# INITIAL FIRE SAFETY INSPECTION REPORT

**Tazkia Apparels Ltd.**

**RSC ID: 26545**

**Inspected By: Md. Kawsar Rubaiat**

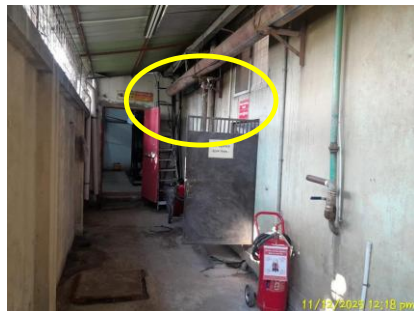
F-16	Means of Egress	<p>Exit signage was not illuminated during testing (burned out, broken, etc.).</p> <p><b>Location(s): 5th floor, Main Production Building.</b></p>	<p>Regularly inspect all exit signage/directional signage as per RSC Technical Guidelines (Standard)<sup>1</sup> V1.0. and replace/install lights as needed to illuminate signs.</p>	<p>Within 1 Month</p>
------	-----------------	--	--	-----------------------
